Access Compliance Report
Public Rights-of-Way
(Curb Ramps)

Main Street: REATA_RD | **Cross Street: N/A** | **Location: SW**

ADA ID: RPRK211118135027 | **Ramp Type:Type 1 - Perpendicular** | **Initial Pass/Fail: Fail** | **Overall Compliance: No** | **Severity Score: 15**

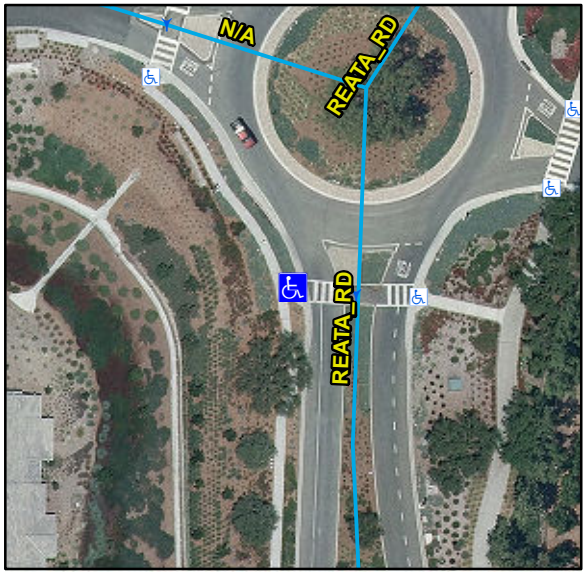
R304.2.2, STD 1115

Remove & Replace Entire Ramp.
